Report on the Edgewater  
to  
The City of Madison Plan Commission

The Mansion Hill Steering Committee on the Edgewater  
February 4, 2010

RE: Edgewater

## **The Roof Deck**

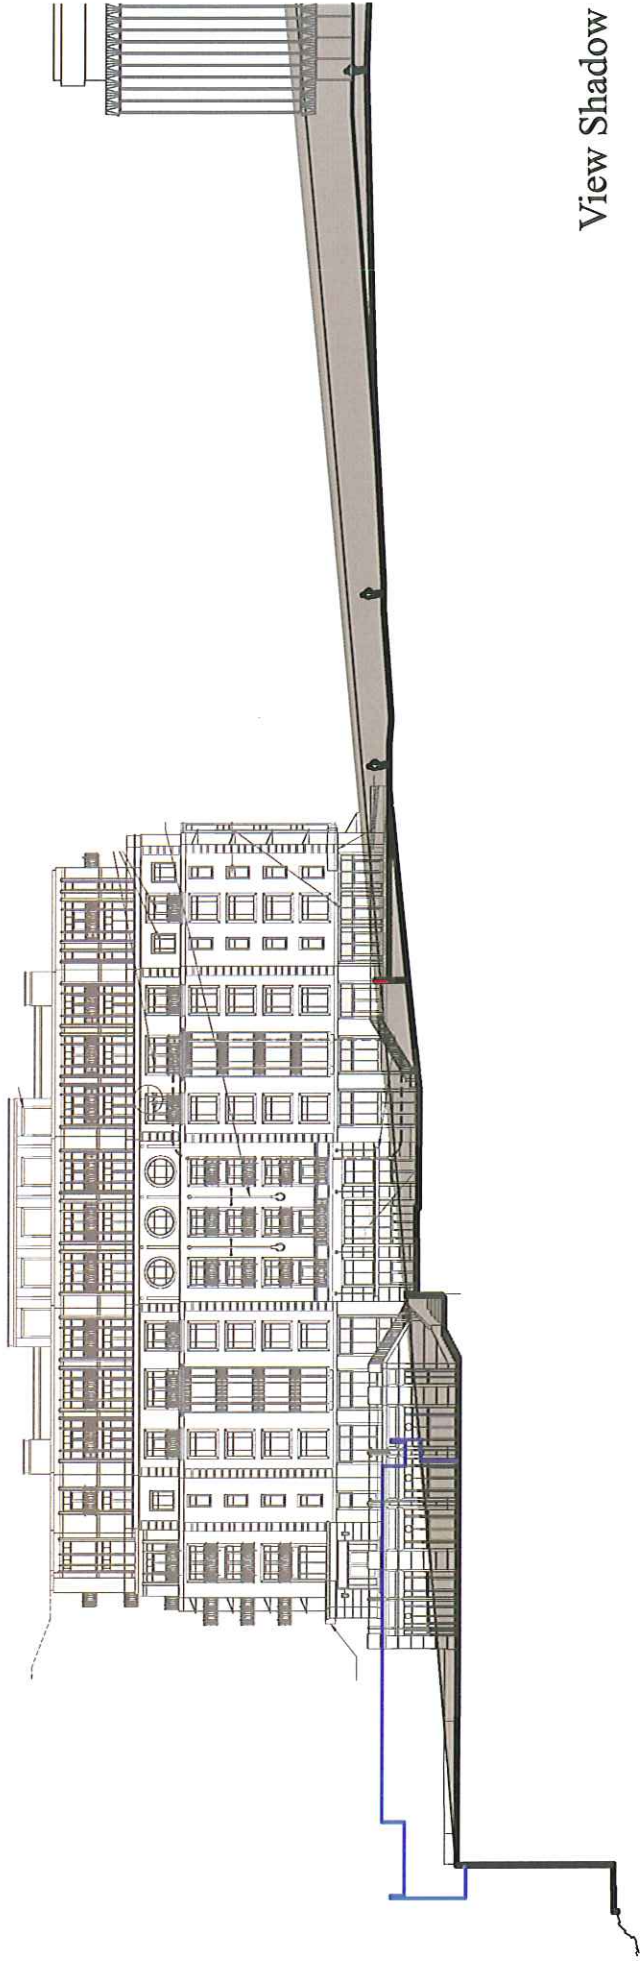
Given the absence of pedestrian traffic in the vicinity and peoples' natural inclination to mingle with other people it would be extremely difficult to draw someone away from State Street or the Union to a unproven, unpopulated new location.

The current design illustrates a nicely detailed and decorated the roof deck but fails to note that it will be completely hidden from Langdon Street, Wisconsin Avenue or any other location in the City except from portions of the Edgewater, One Langdon and Two Langdon. The tiered two-story tall parking structure between street and deck simply

This is a correctable flaw but as presented the roof deck will be completely hidden from view and "Out of sight is out of mind". The public benefit promised can not be delivered.

View Gained  
 Demolition of 70's Addition  
 View Lost  
 Proposed New Tower

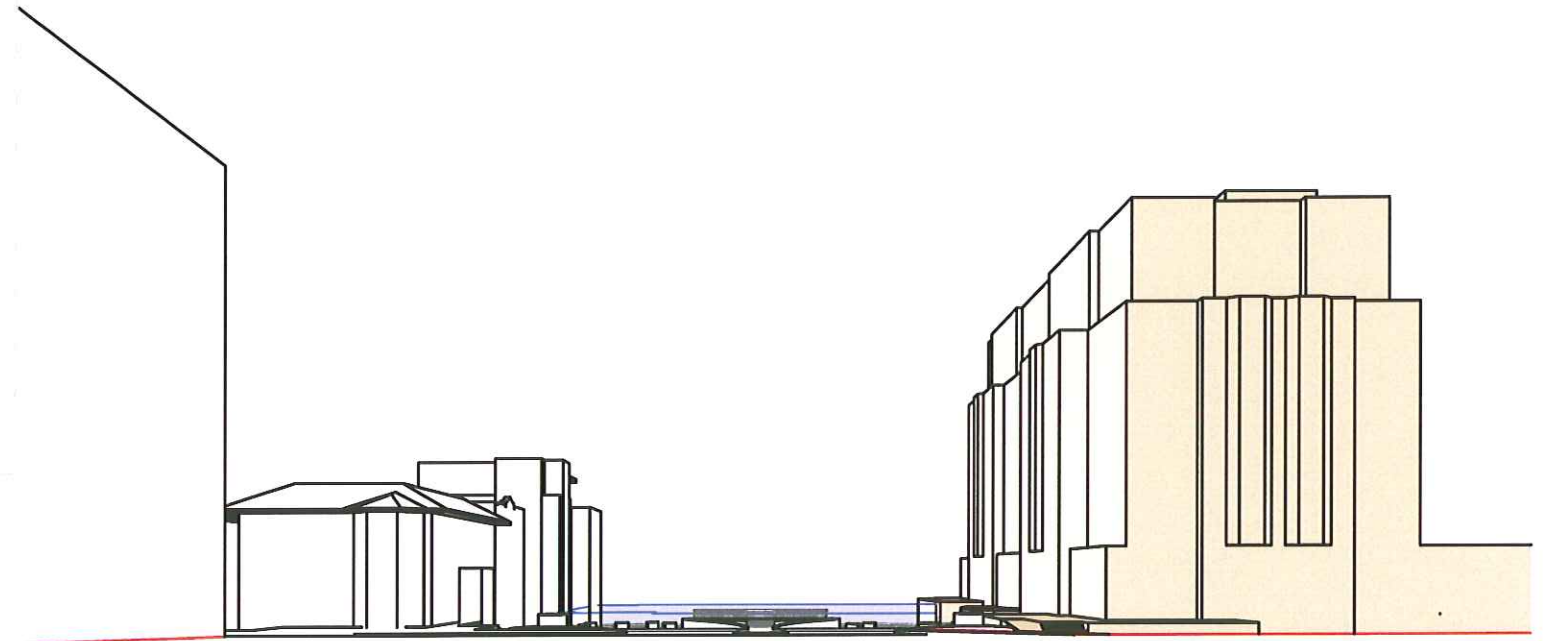
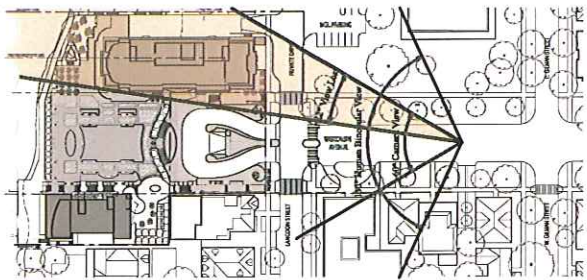
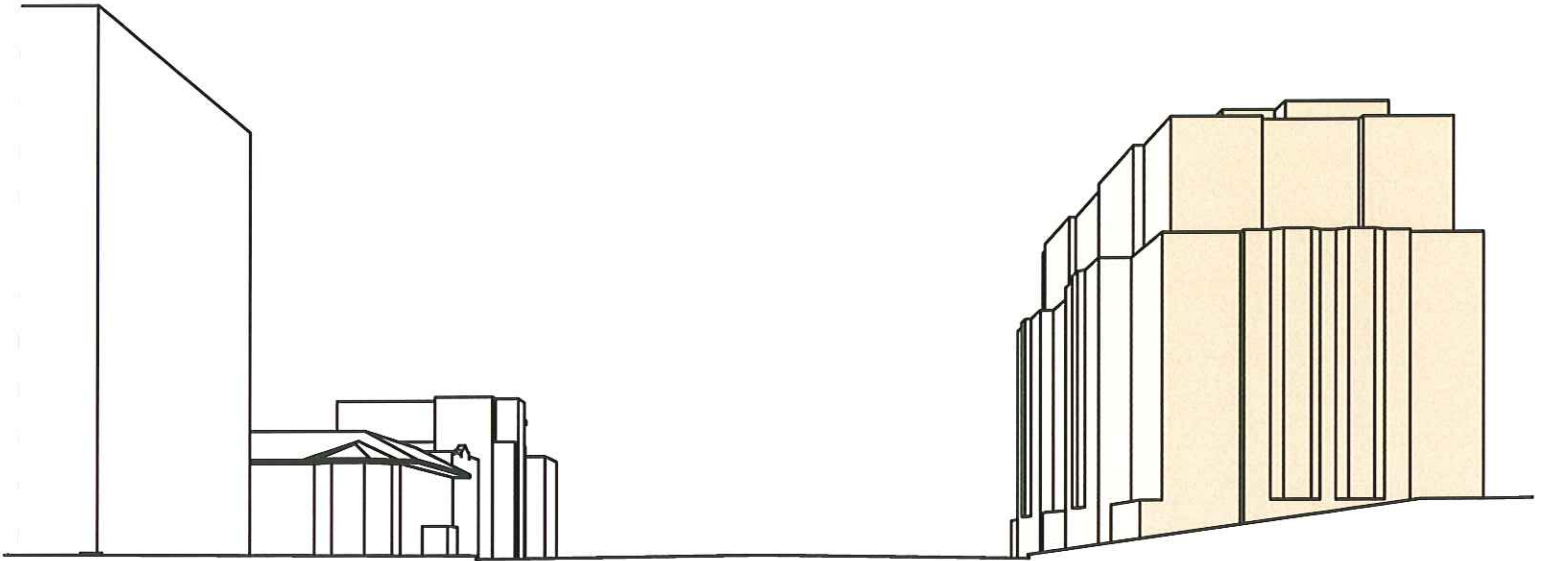
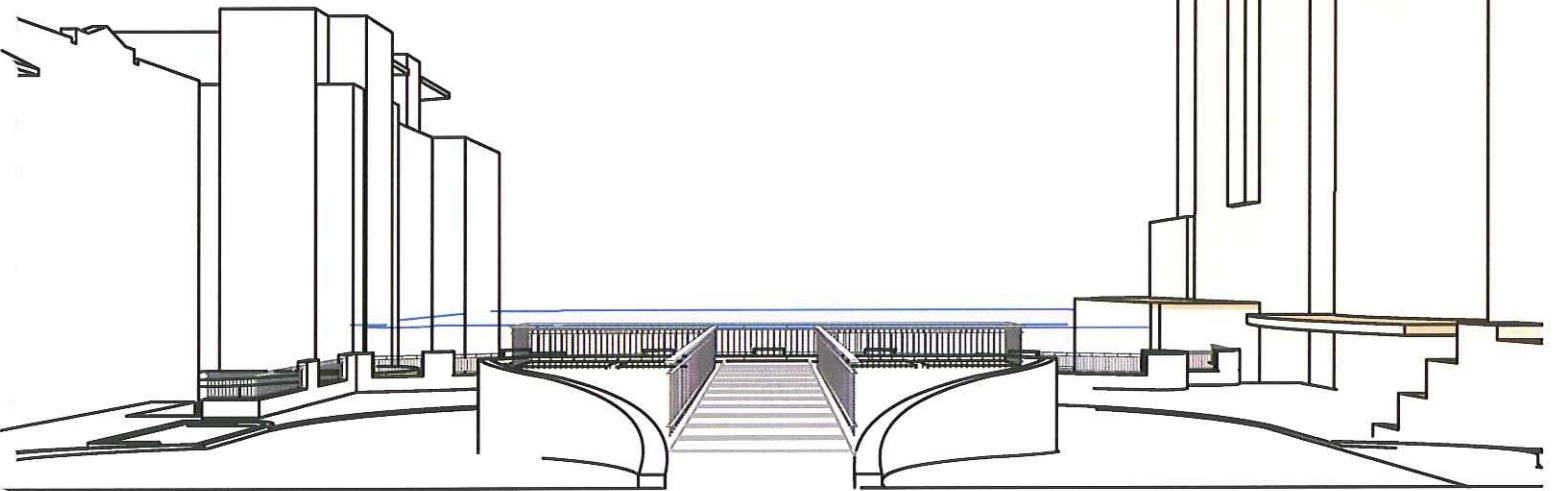
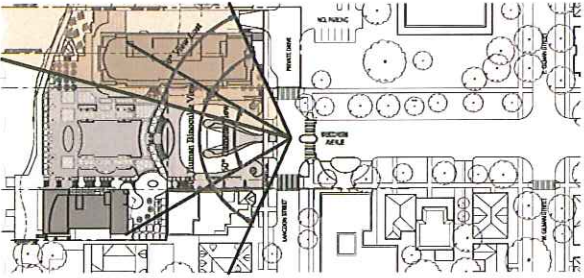
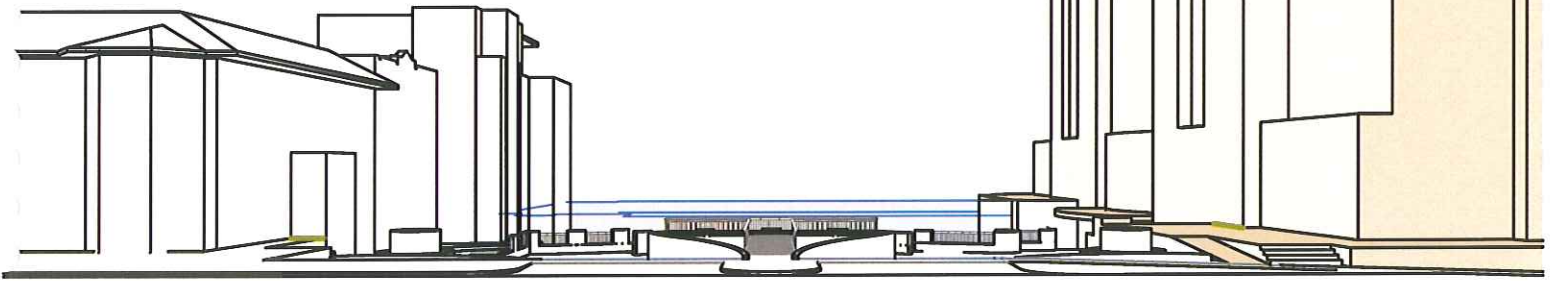
The removal of the 70's addition has been presented as providing an opportunity for opening up the view of the lake from the end of Wisconsin Avenue.

Unfortunately the location and configuration of the parking structure blocks much of the view gained from the demolition.

The structure as designed largely obscures both the stair down to the lake and the lower levels of the newly restored original Edgewater building and blocks from view the entire roof deck,

In return for additional glimmer of lake that will be seen from a two hundred foot stretch on one block we are being asked to accept a massive new tower built tight to the right of way in the middle of an historic district that will be seen for miles and intrude on the view shed for the full length of Wisconsin.

## The Stair

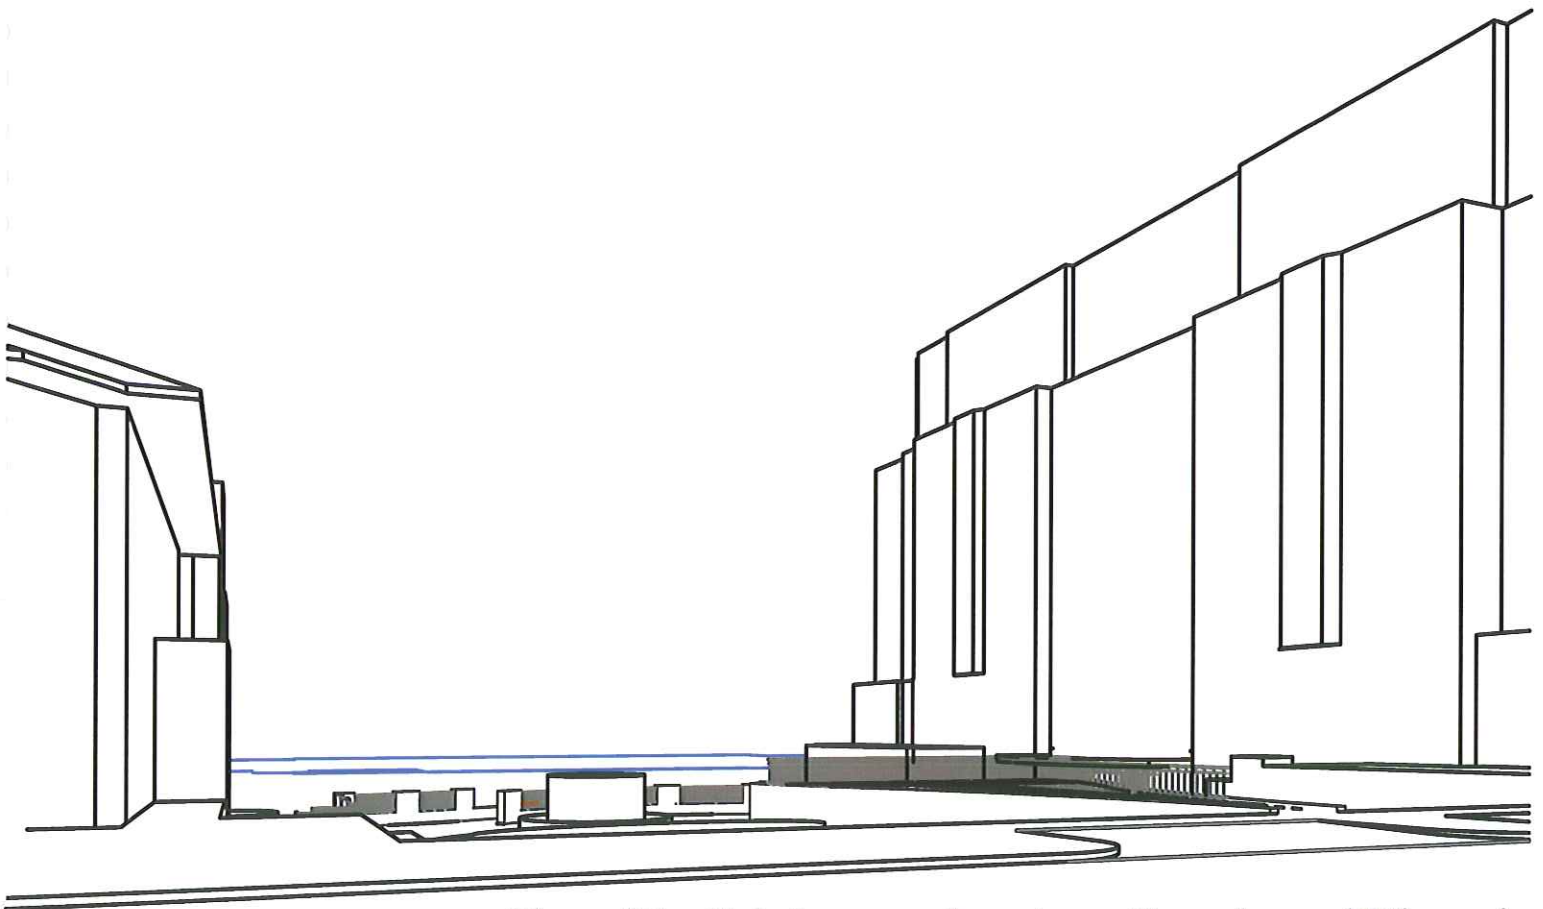
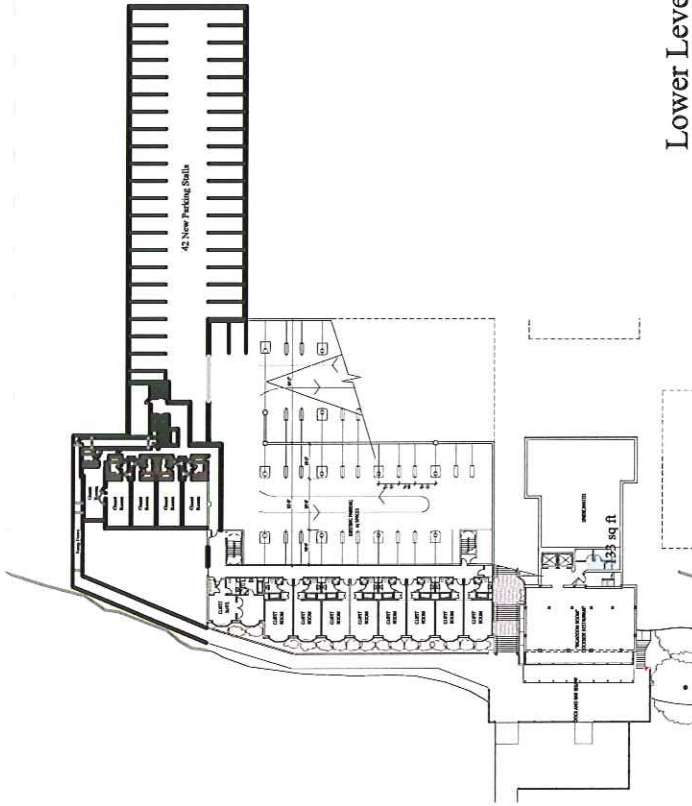
The existing stair from Langdon to the hotel for all its lack of charm follows the contours of the hillside and thus plainly visible. It is also of manageable length and its terminus is in plain sight. The limited number of patrons that enter and leave the hotel on foot clearly favor the stair walk.

The new replacement stair is consigned as it is to a narrow slot between the parking structure the existing building at Two Langdon effectively shielding it from view street side. By its very nature a stair is typically lacks visual presence when can be seen only from above and this one is no exception. There is scant evidence of its existence from Langdon Street and it is invisible from Wisconsin Avenue. With the absence of visual cues this stair will be little noticed and will elicit only infrequent serendipitous discovery,

With its sixty foot, 116 step, six plus story height this particular stair presents an intimidating challenge to fitness level of a substantial portion of the population and will require a discomforting level of exertion for most people. Few will attempt it and even fewer will use it twice.

Lower Level Six - Two @ 1" = 100'  
 The Edgewater Reconsidered  
 December 8, 2009

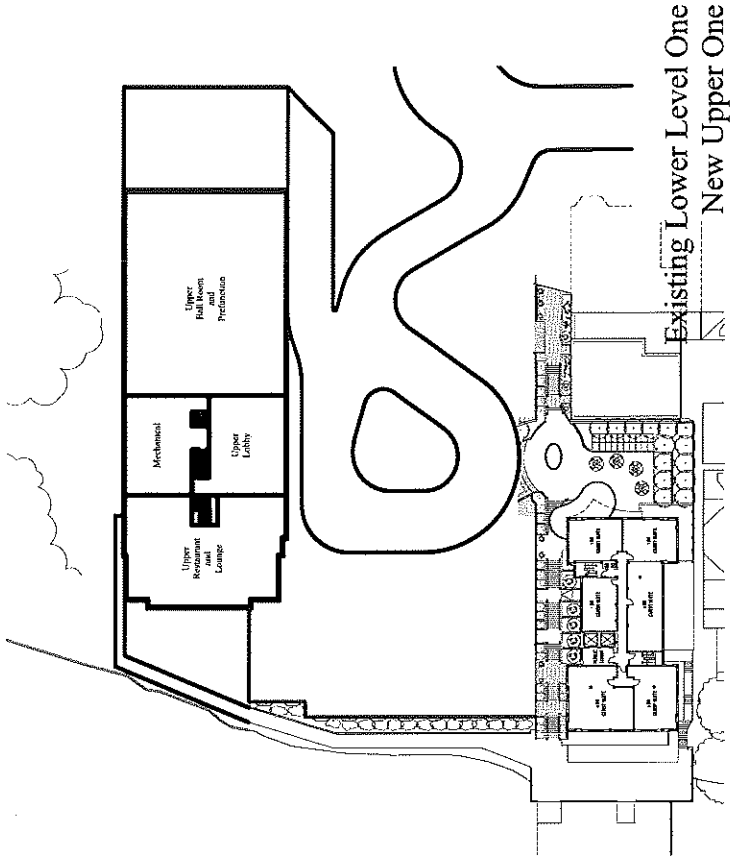
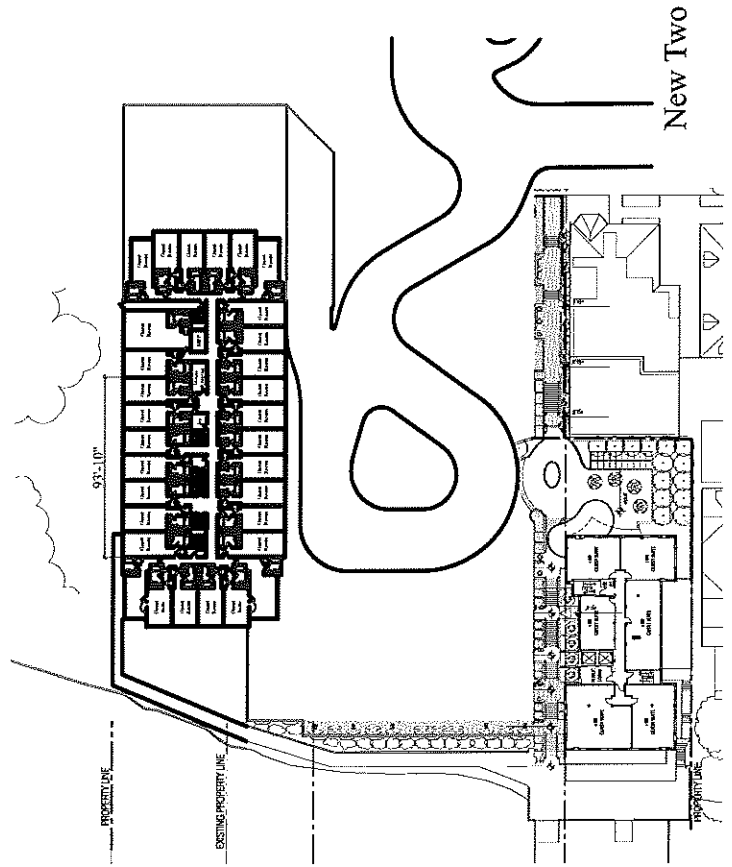
Lower Level 6	42
Lower Level 5	42
Lower Level 4	42
Lower Level 3	14
<b>Total Parking</b>	<b>140</b>
As Proposed	73
As Reconsidered	140

Gilman Street Elevation @ 1 = 20'  
February 1, 2010

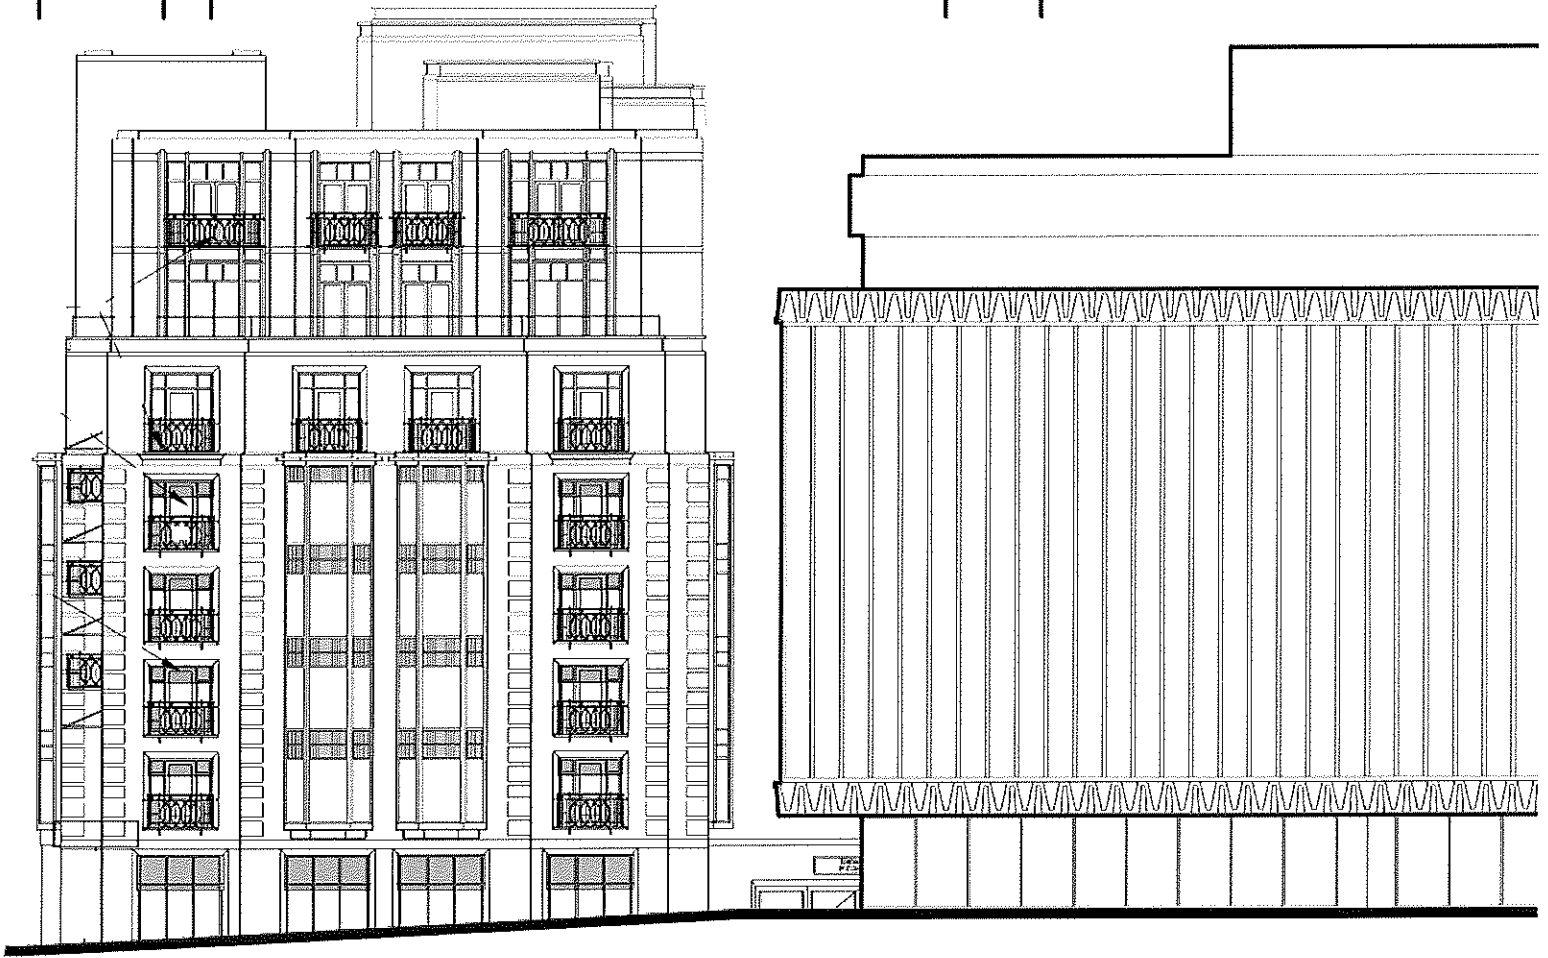
From the perspective of the larger urban context there is no issue more important maintaining the long established shared common setback and the preservation of the view corridor that Madison has kept in trust for 174 years.

The portion of the National Guardian site allocated for the expansion is 105'-4" wide and the tower as proposed is 70'-4" wide. The building can be shifted back 35'.
